1st Review
PRCCP20240569
June 2024

ASH DEVELOPMENT, LLC
EAST TOWN CROSSING
PUYALLUP, WA

PAVEMENT MARKING &
SIGNING PLANS - PHASE 1

TRAFFIC SIGNAL PLANS - PHASE 1

SIGNAL CONSTRUCTION NOTES:

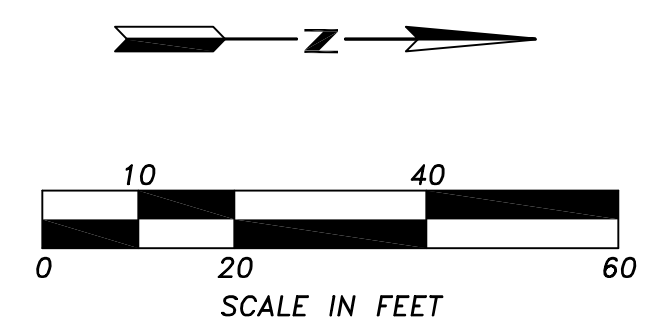
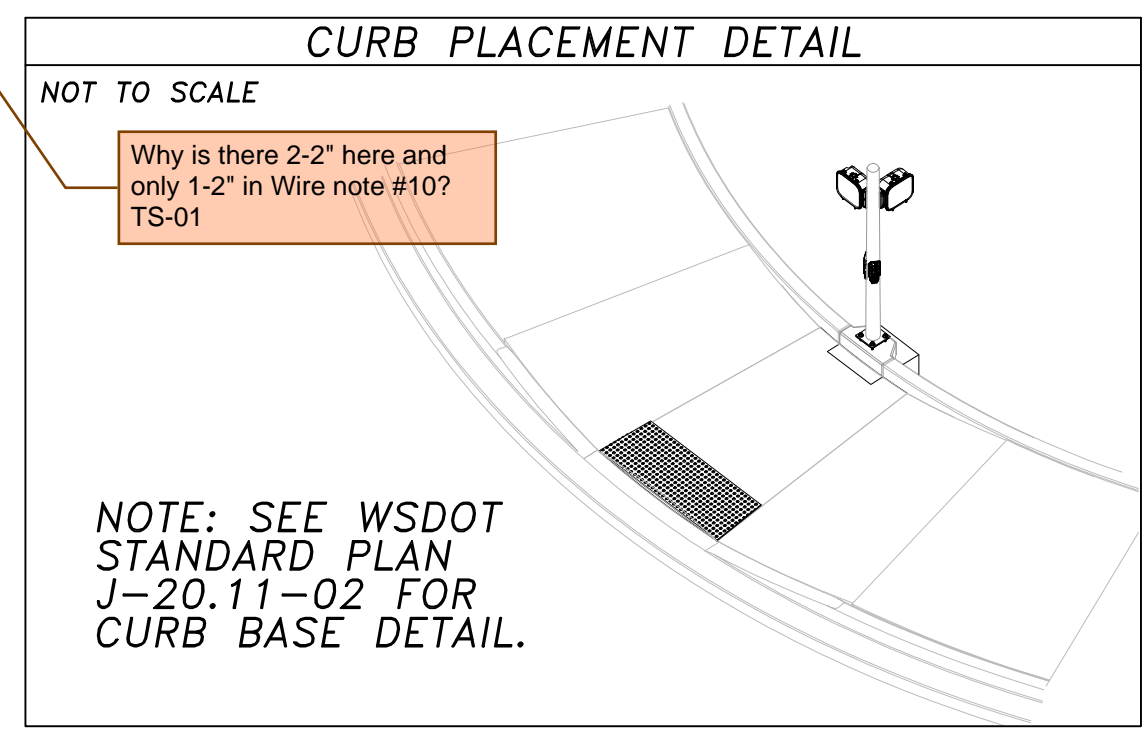
As condition with the preliminary site plan approval, the required signal/intersection modifications must be fully configured and operational no less than 2 weeks prior to receiving occupancy for any building on-site. Adaptive signal contractor (Rhythm Engineering) will be required to configure the adaptive system on-site. Adaptive contractor will provide setup/configuration/optimization (not completed by the City). Place this condition on the plans. TS-01

Adjust east/west lane striping to accommodate left turn pocket and shared thru/right turn lane. To accommodate this phasing, the EBR overlap must be removed TS-01

As condition with the preliminary site plan approval, Flashing yellow arrows with PT/PM phasing required for EB/WB left turns. Modify phasing as needed TS-01

Per the approved preliminary site plan conditions, provide details on overhead fiber connection and how it will be spliced/connected to cabinet. TS-01

Update phasing diagram to reflect PT/PM FYA operation for EB/WB. TS-01

To accommodate required channelization (left turn pocket and shared thru/right turn lane), EBR overlap must be removed TS-01

RSSZ flasher
-Coordinate with the City for required hardware & wireless interconnect
-Show conduit/j-box/power source/etc.
-Reference applicable WAC with placement/design justification.
-MUTCD compliant advanced signage/pavement markings missing from design TS-01

TRAFFIC SIGNAL WIRE SCHEDULE - PHASE 1
 TS-02
 SHEET: _____ OF _____

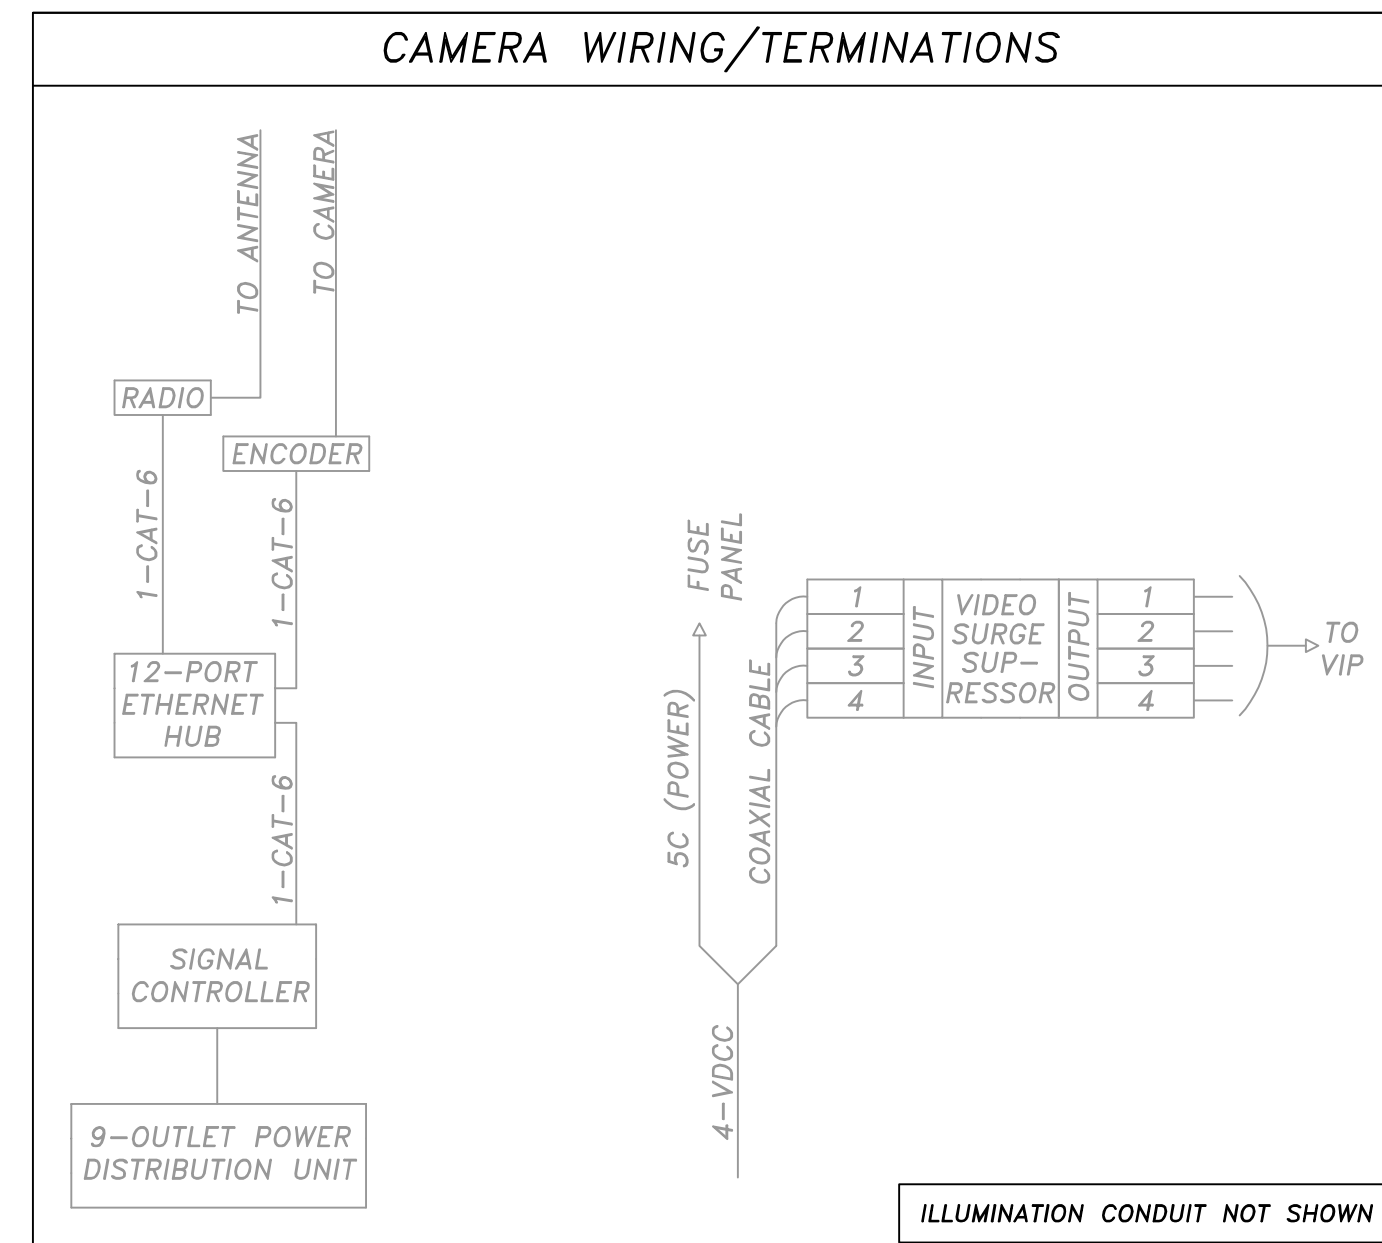
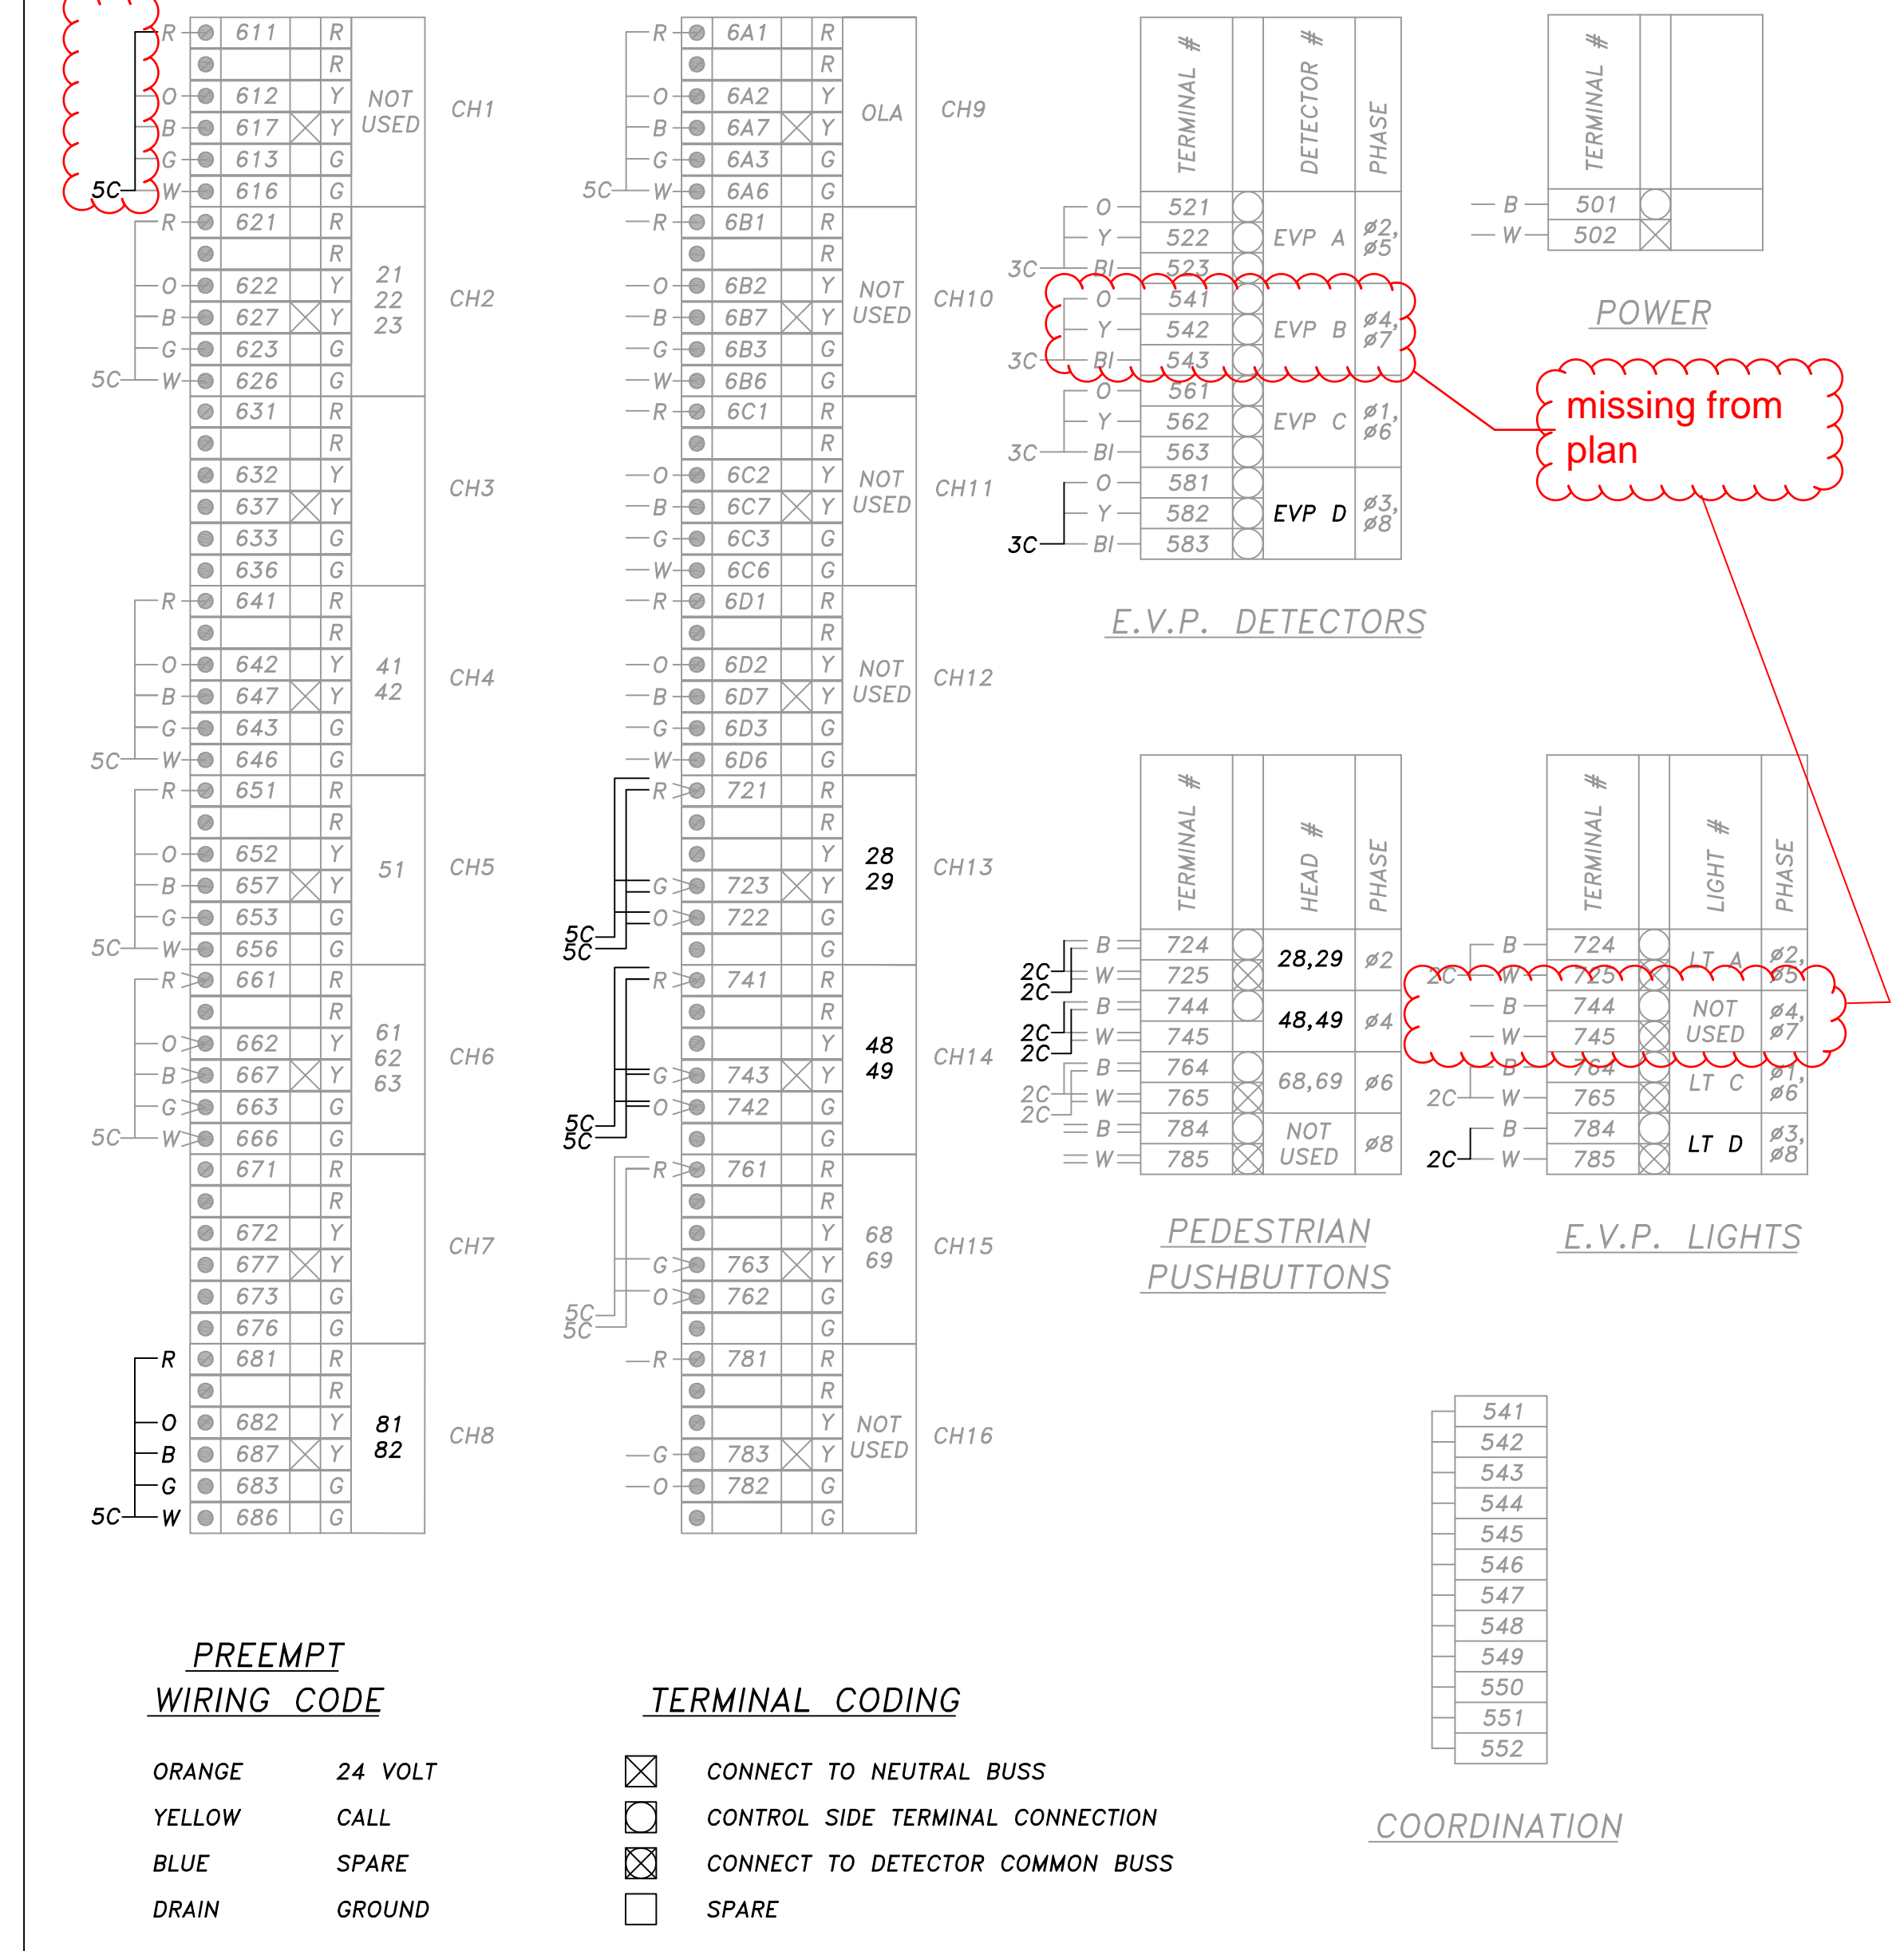
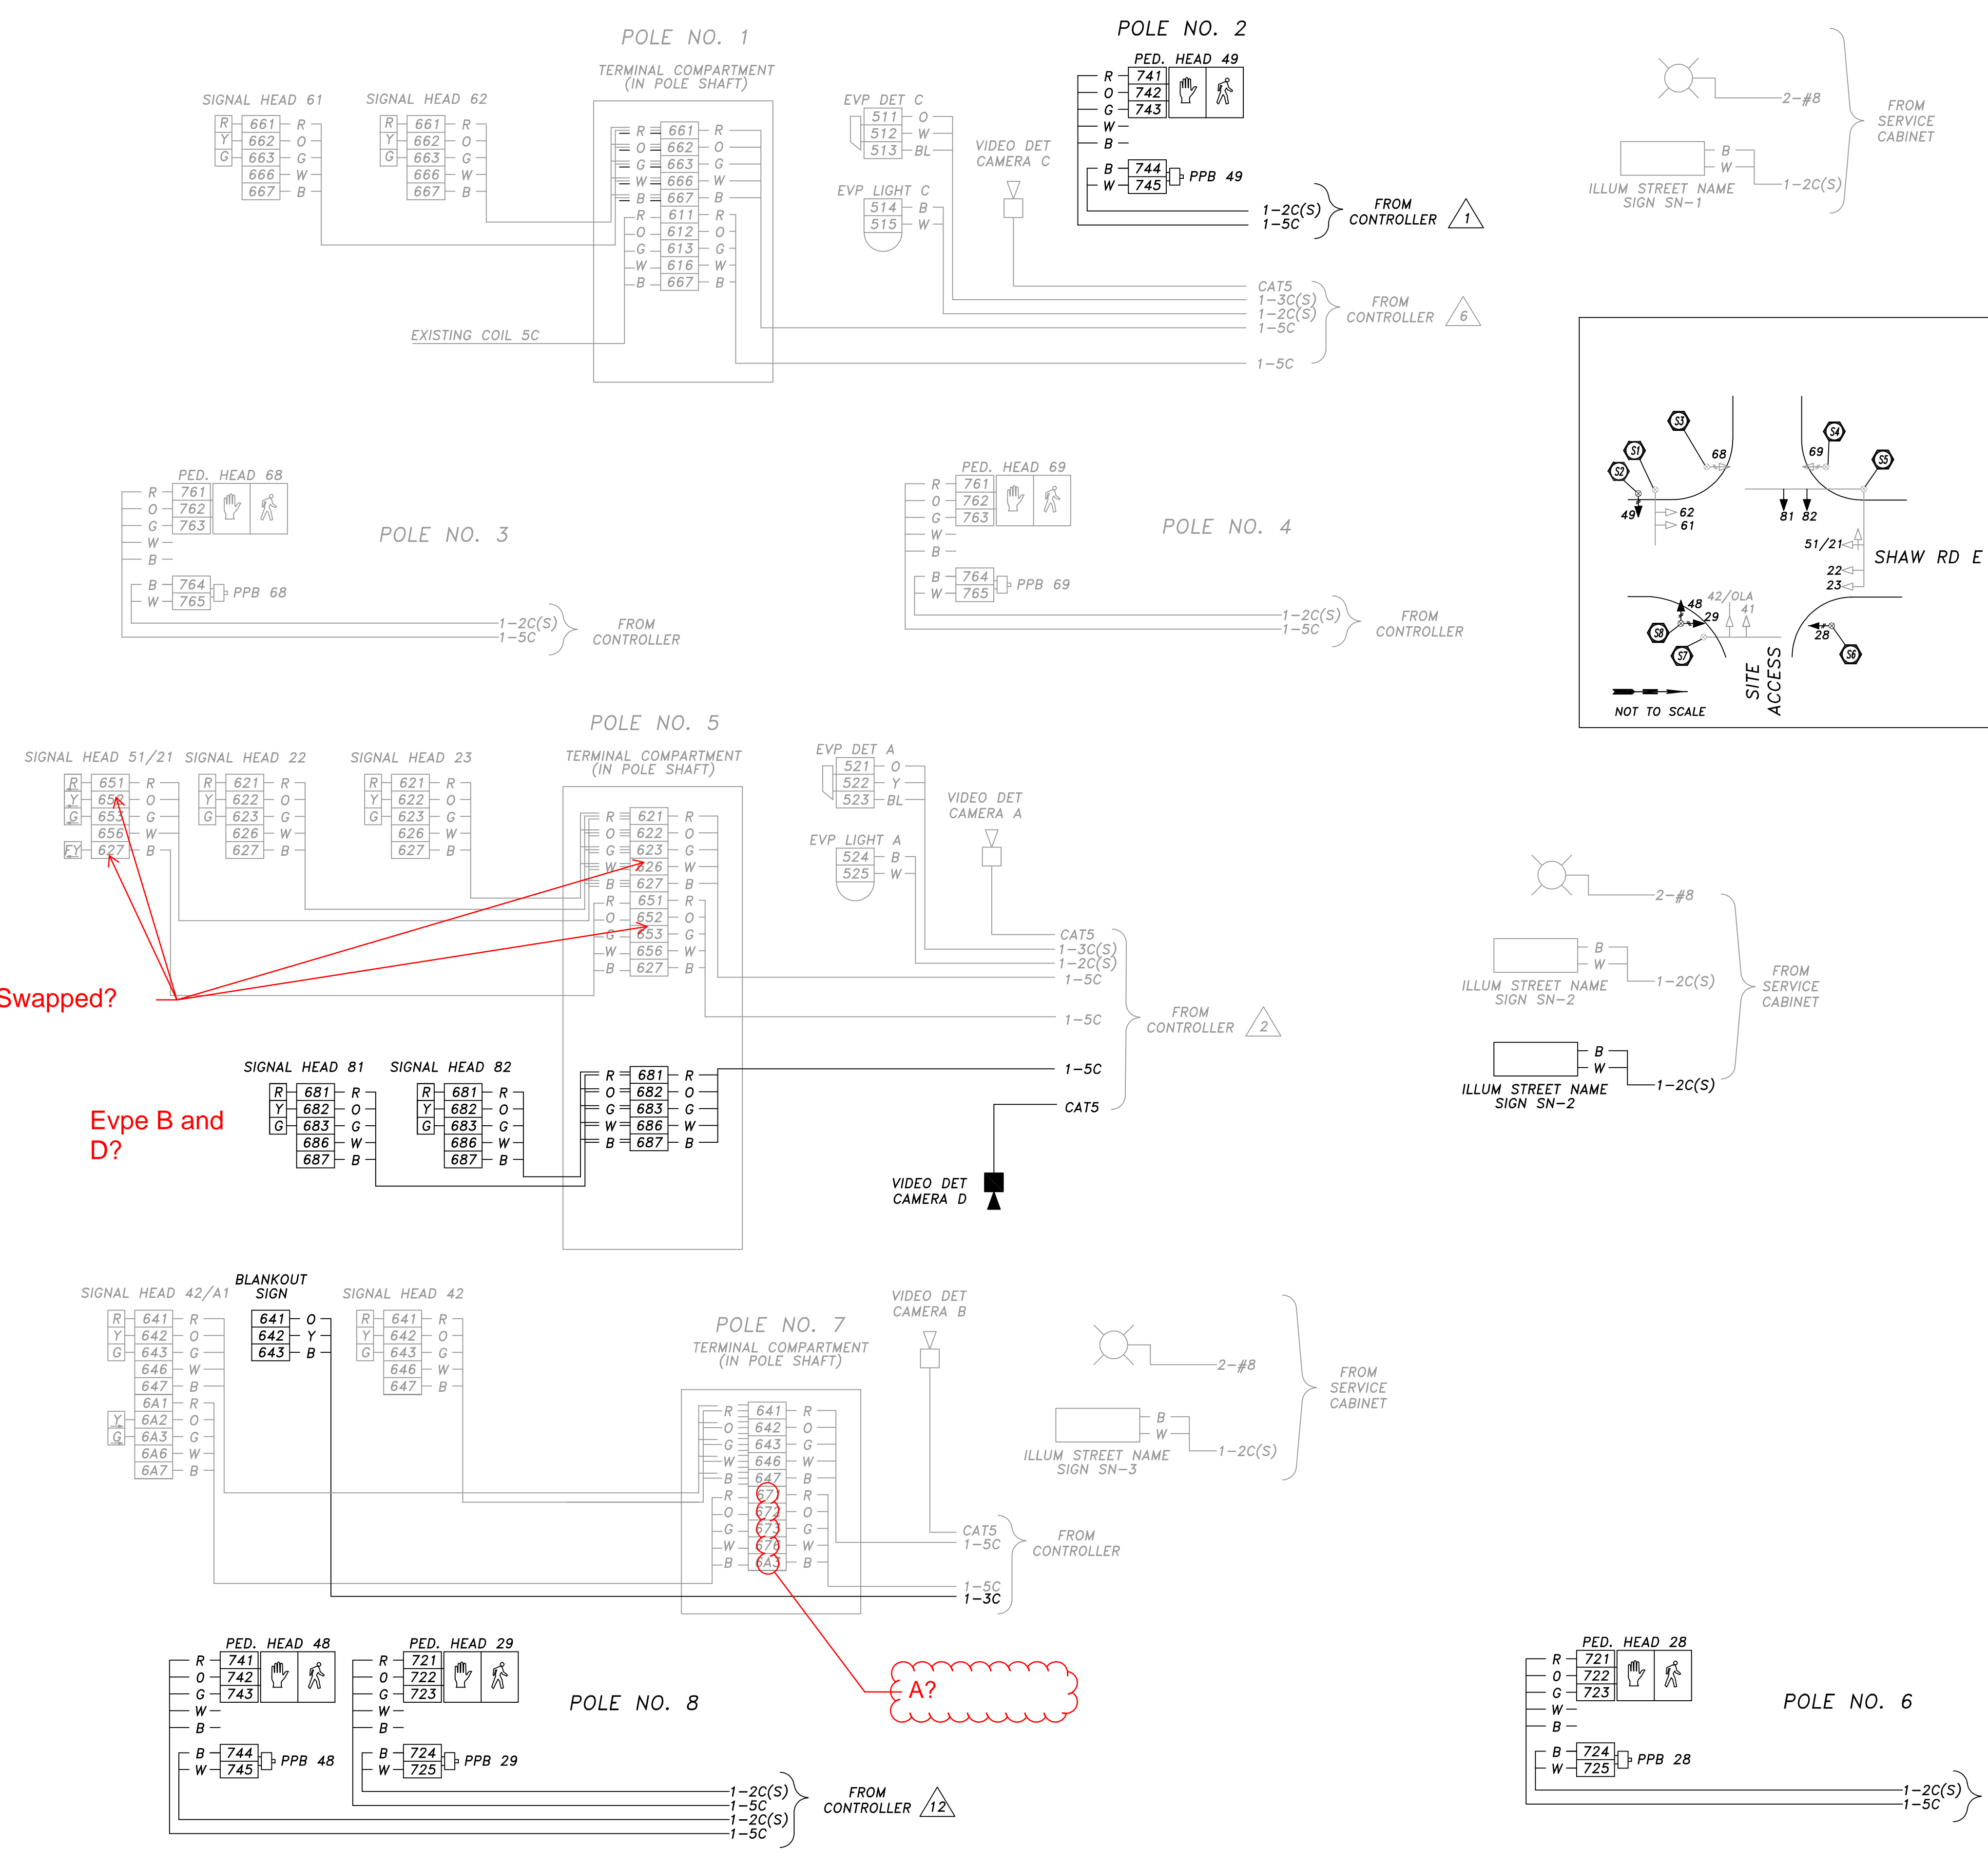
No spares? →

Type PS pole receiving Type PS pole? →

Swapped?
Evep B and D?

missing from plan

A?
